Los Alamos County
Community Development Department
PLANNING & ZONING COMMISSION

Public Hearing Date: May 22, 2019
Subject: Case No. SIT-2019-0034
Property Owner: Shannon Corp, LLC / JEA Restaurant Group
Applicant: Agent Craig Calvert; Modulus Architects, Inc
Case Manager: Anita C Barela, Associate Planner

Case No. SIT-2019-0034:

01 ARCHITECTURAL SITE PLAN
 SCALE: 1/8" = 1'-0"

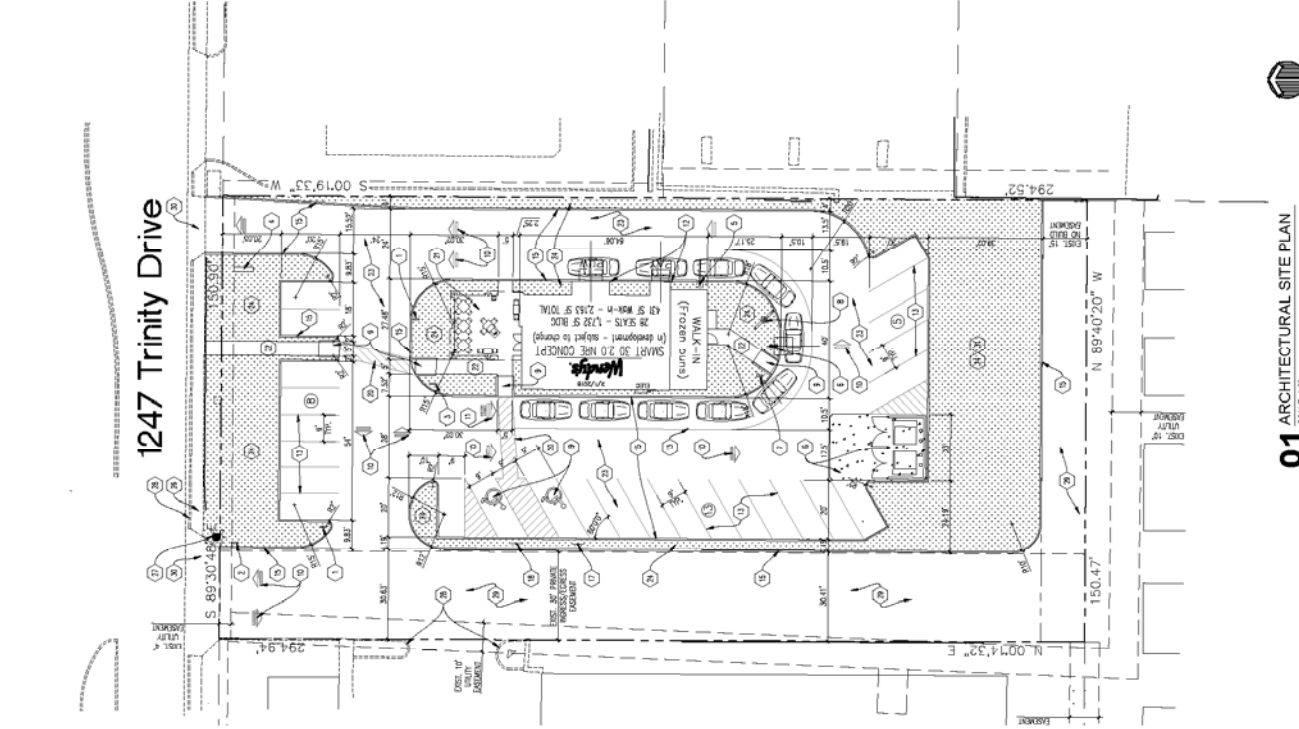
The applicant shall make ADA ramp improvements to the frontage sidewalk along Trinity Drive. ADA ramps should be shown at the handicap parking spaces.

Provide additional storage and queuing capacity for the drive-up service window to mitigate traffic overflow onto Trinity Drive (NM 502) during the noon peak hour—the western and southern portions of the lot may be utilized in similar fashion as the previous use.

Provide delivery truck turning templates to demonstrate adequate truck ingress/egress—provide site plan adjustments to accommodate delivery trucks as necessary. [Engineering]

The site plan should show the proposed site lighting pole locations. A photometric plan will be required with the building permit submittal. [Engineering]

LANDSCAPE PLAN

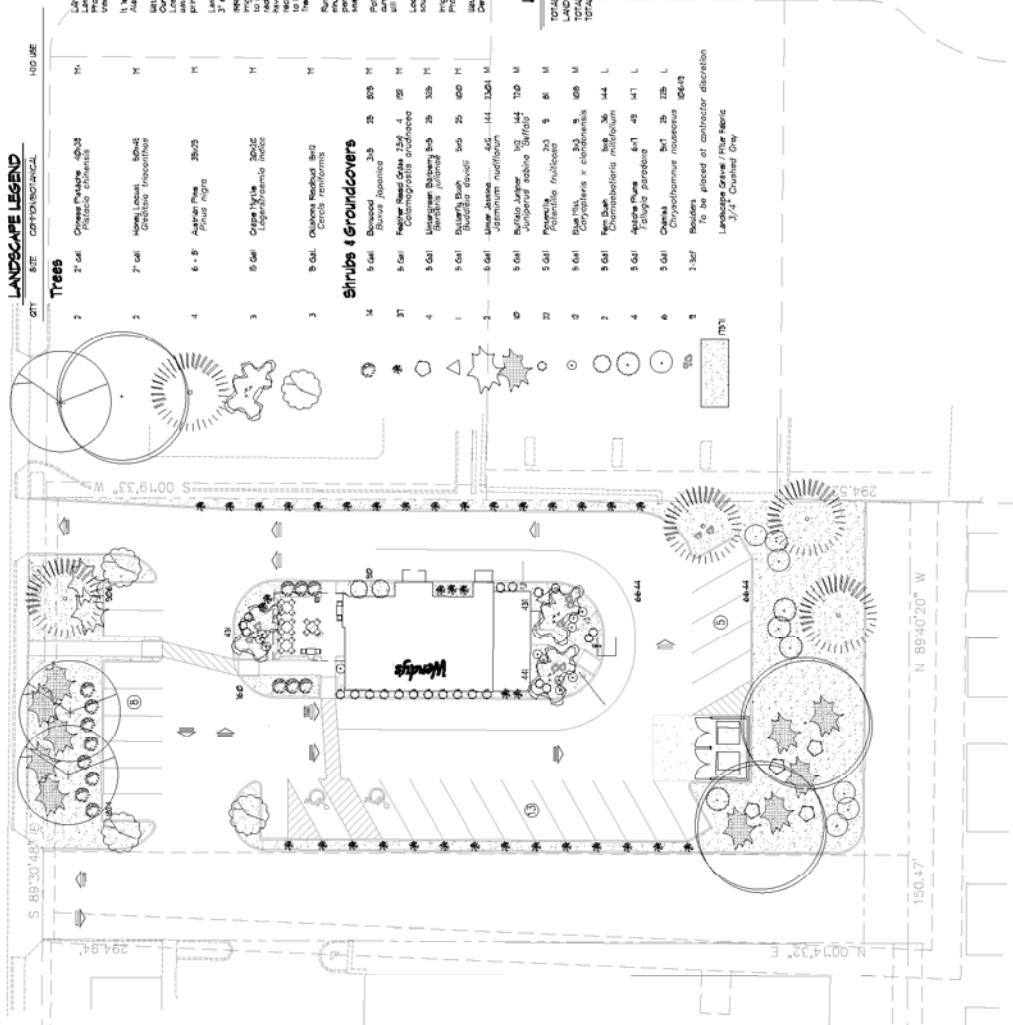
Staff Comment: The Landscape Plan submitted in support of the revised Site Plan exceeds the minimum five percent requirement for landscaping material, as required by Section 16-574 and Section 16-575 of the Los Alamos County Development Code. It is strongly recommended that all existing trees be protected during construction. A detail note shall be placed on the revised landscape and construction plans. [Planning]

CONCEPTUAL DRAINAGE PLAN

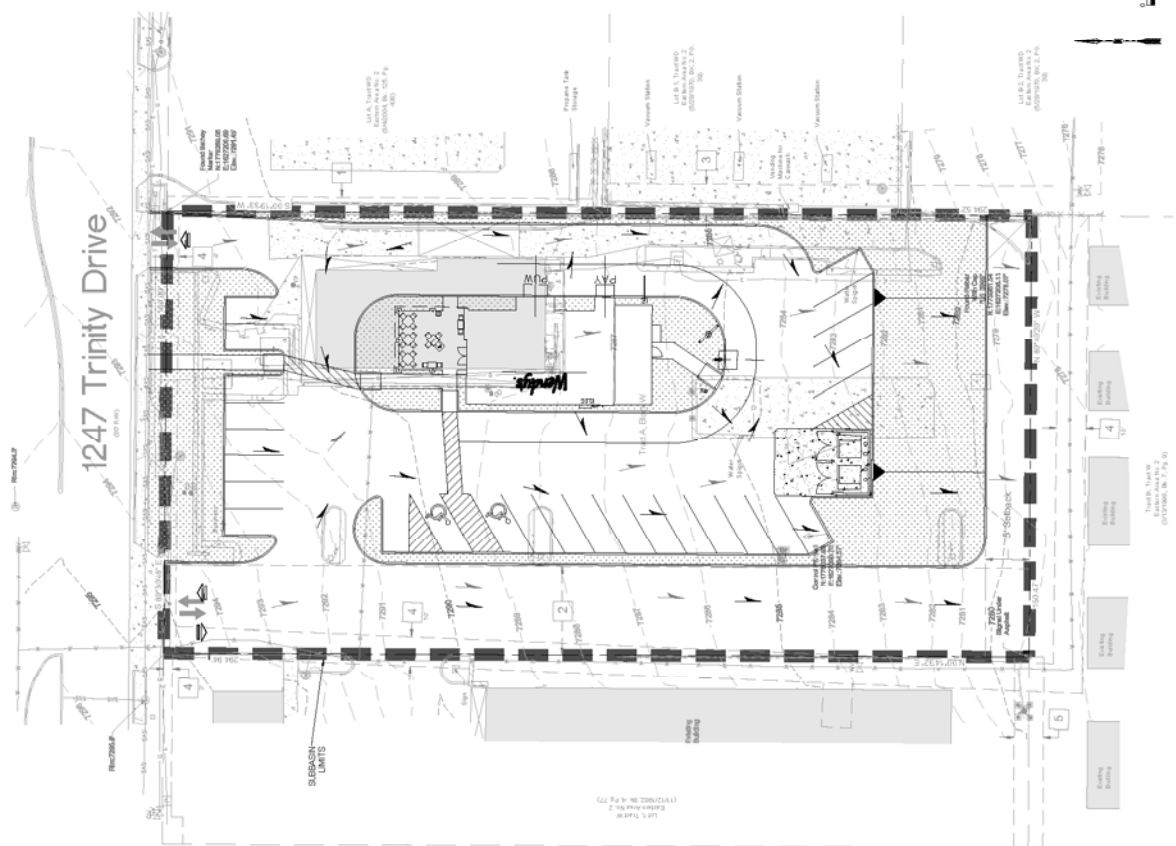
Staff Comment: Provide on-site storm water detention to mitigate drainage impacts to adjacent lots—above ground first flush Low Impact Development (LID) ponding methods in combination with landscaping, or underground detention options may be utilized. [Engineering]

02 TRASH ENCLOSURE PLAN
 SCALE 3/8"=1'-0"

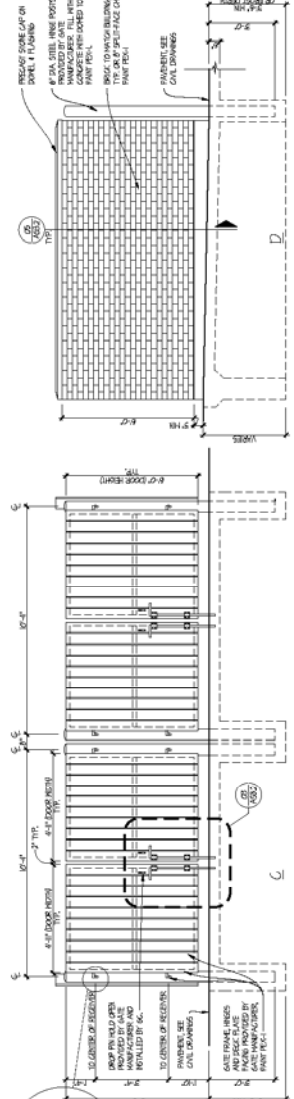
The Los Alamos Environmental Services division's double dumpster enclosure specs require Bollards must be 18" from the back and side walls of the 10' x 21' enclosure. [Public Works, Environmental Services]
